## ADDENDUM #02

### ADA Compliance Upgrades Foussat and Libby

#### BID NO. 2025-21-070B

## RFI #12: Concrete Substitute for Asphalt

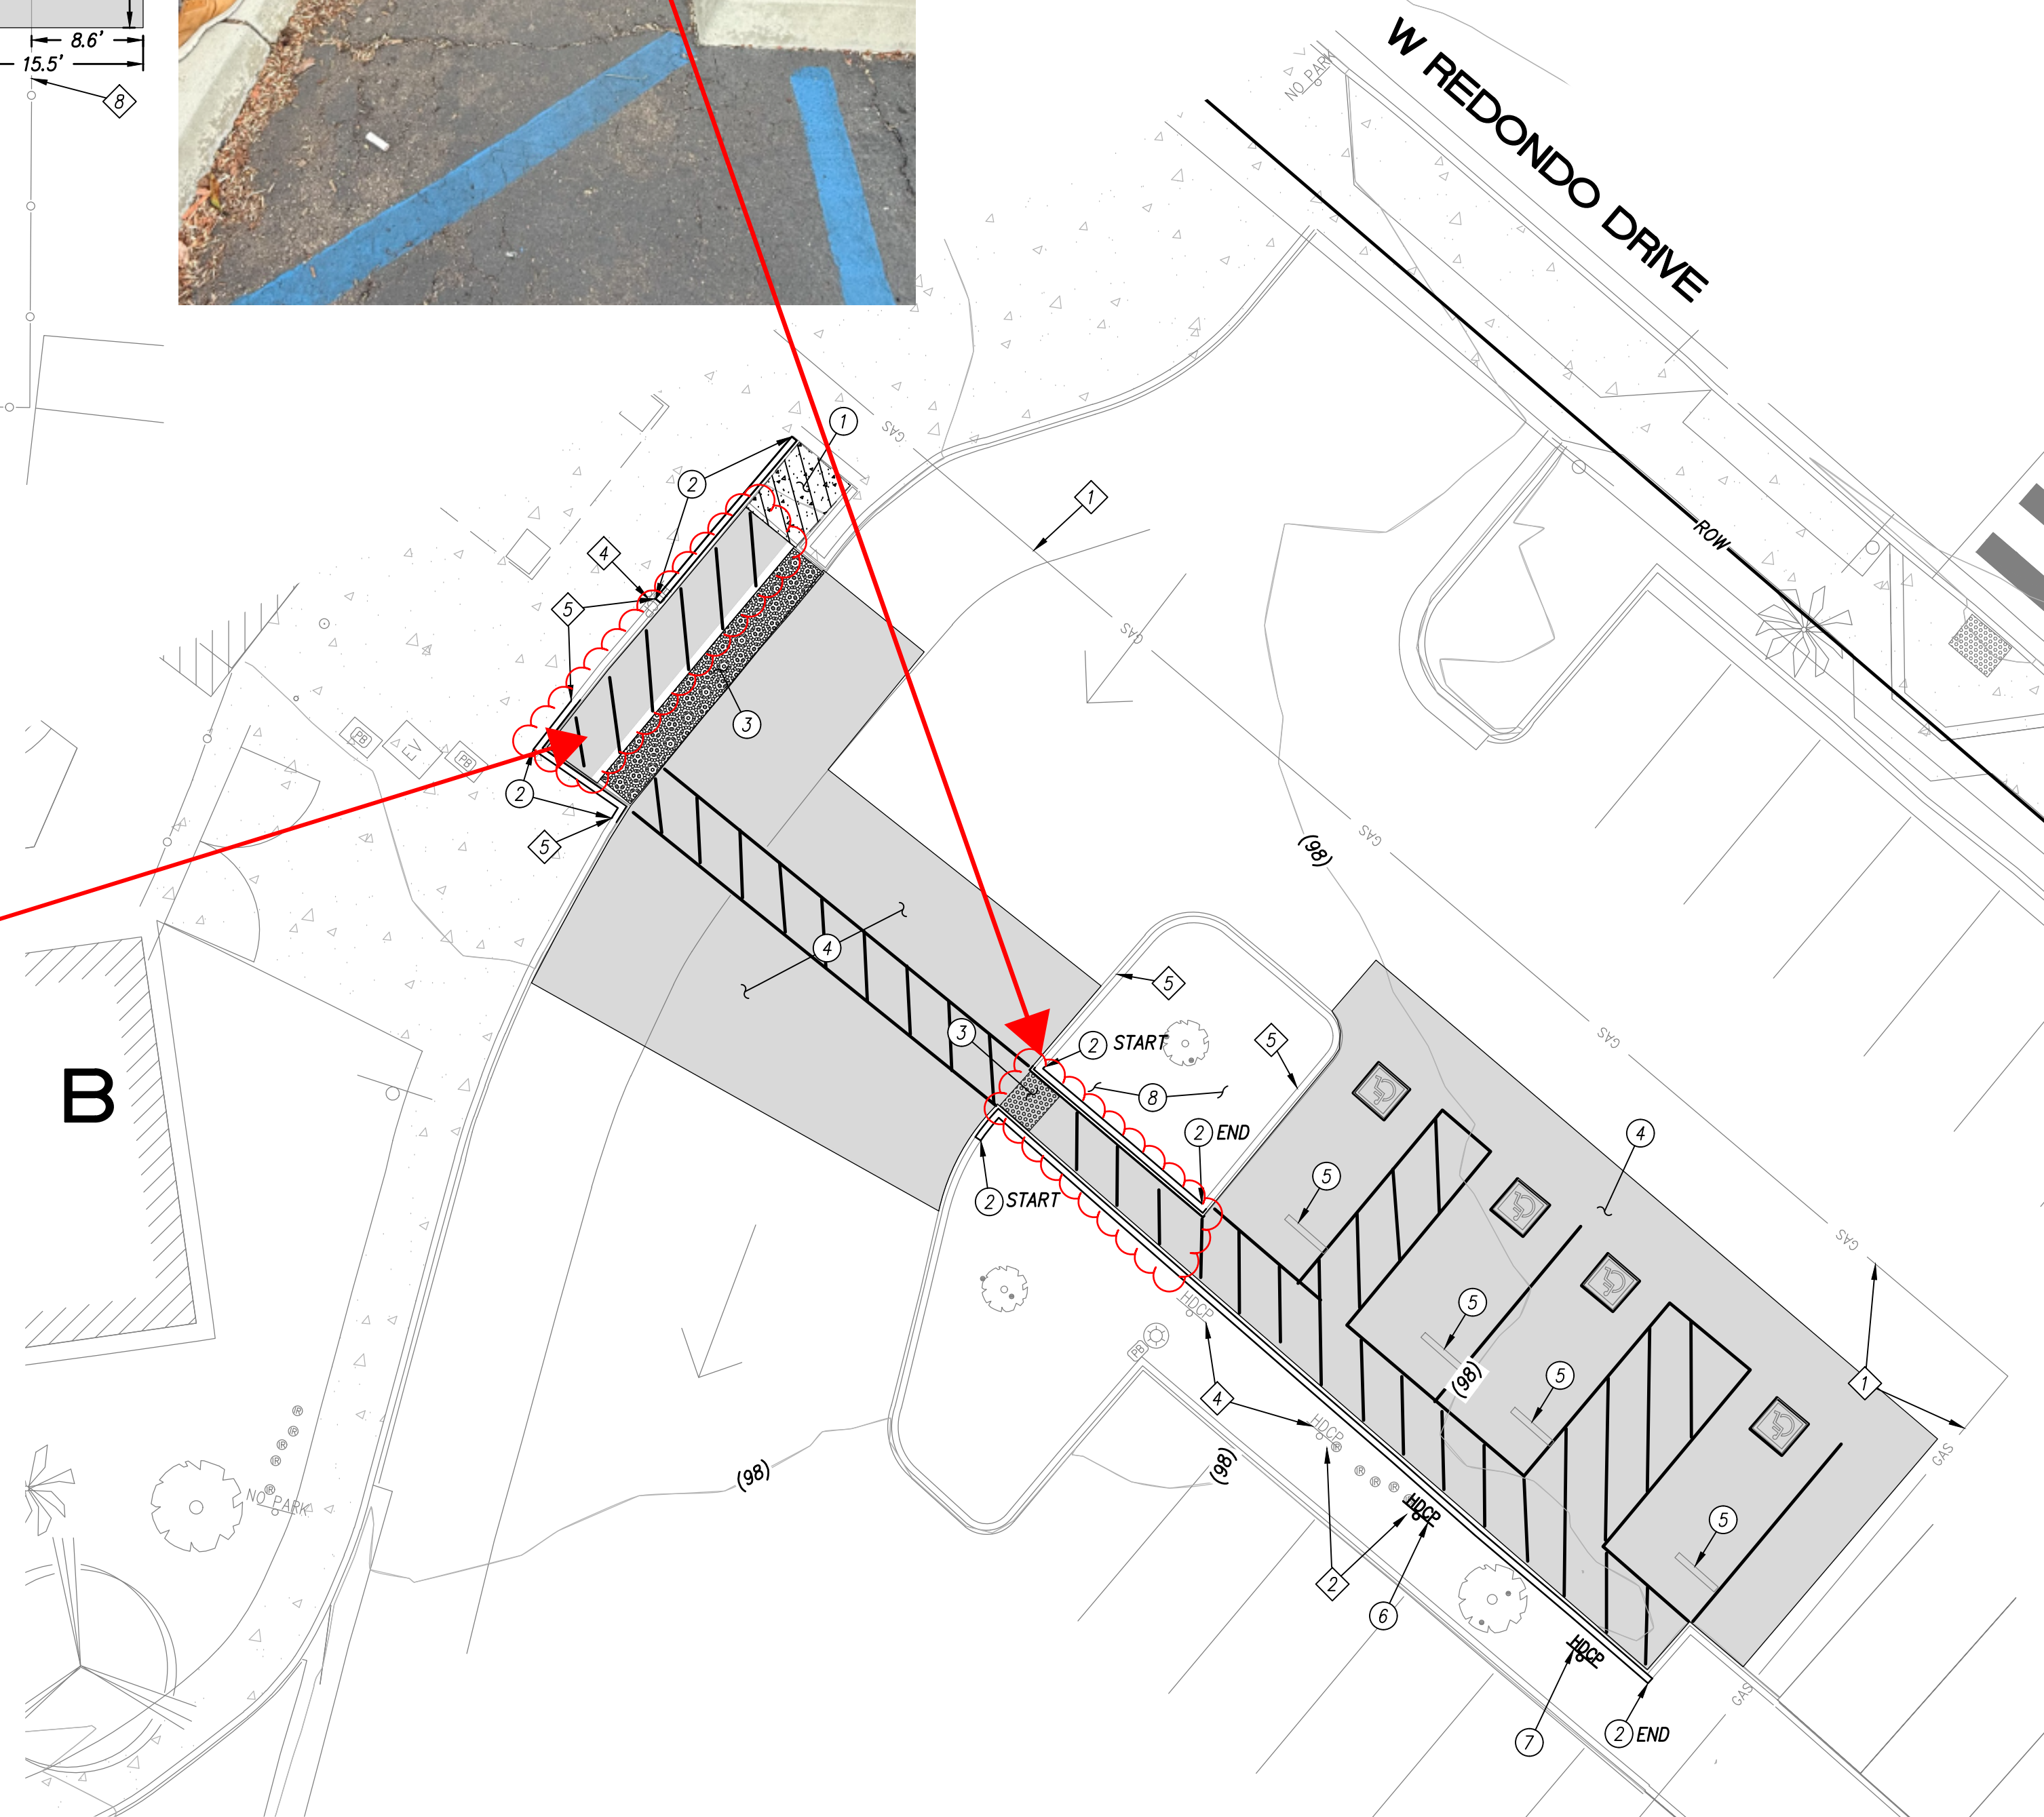
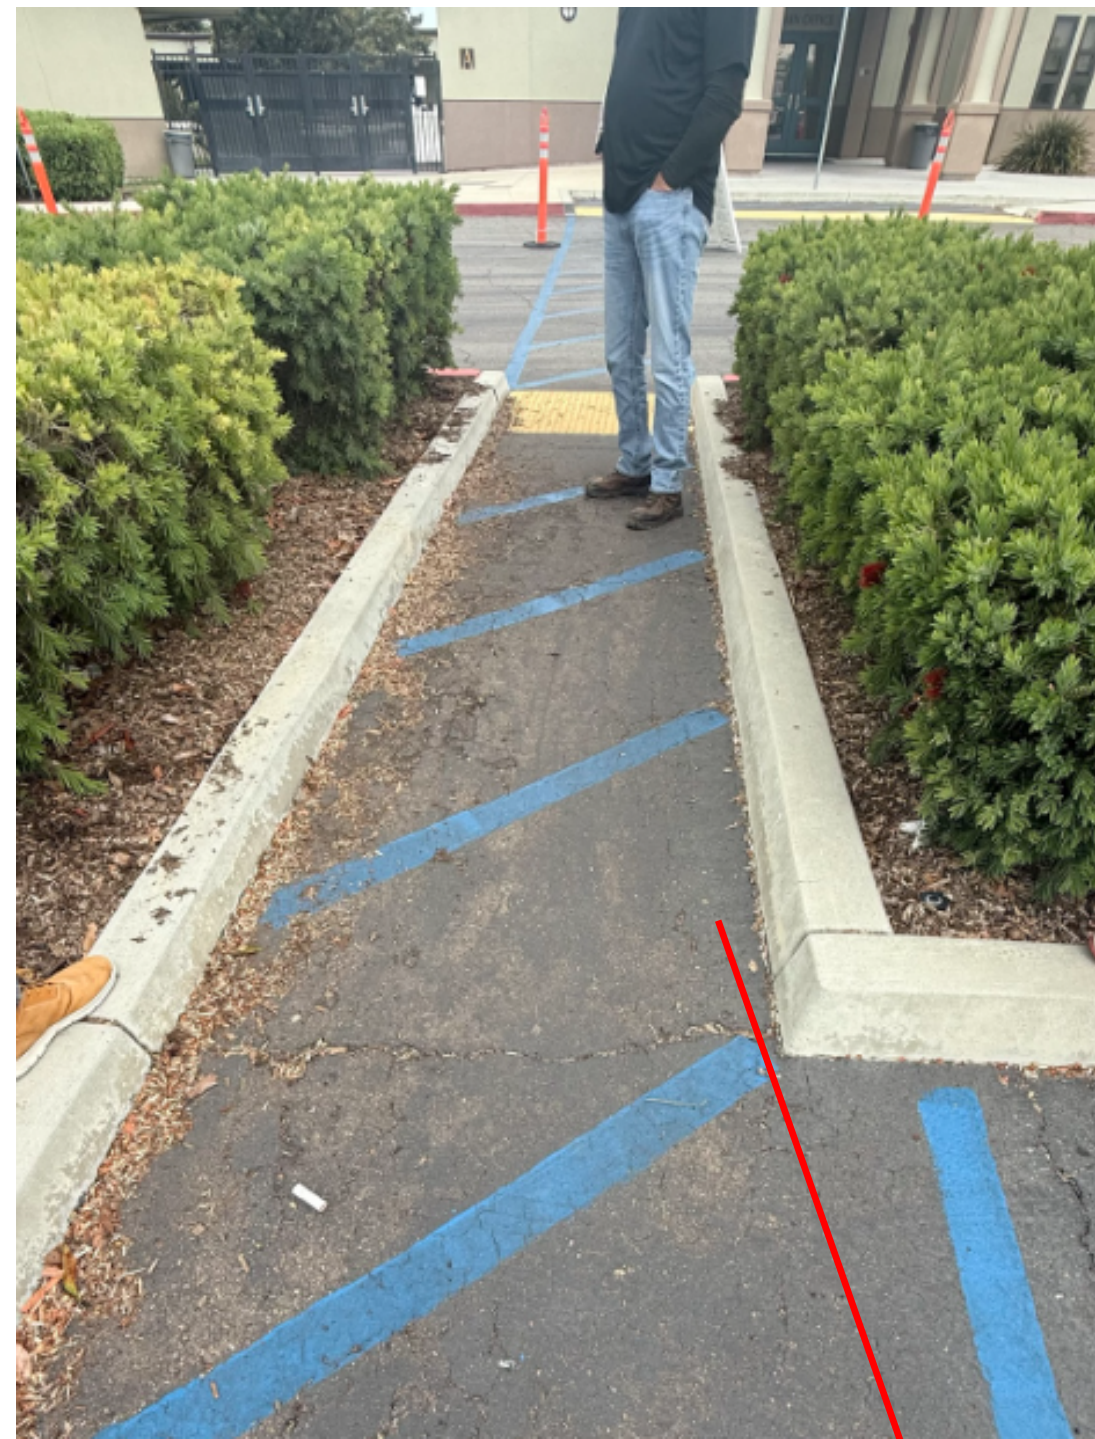
Please confirm it is acceptable to place concrete opposed to asphalt at the two locations identified within the attached.

Question	Response
RFI #12 Concrete Substitute for Asphalt Please confirm it is acceptable to place concrete opposed to asphalt at the two locations identified within the attached.	Where concrete is substituted in lieu of AC in the traffic areas, concrete shall be at least 6 inches thick on 3 inches of base.
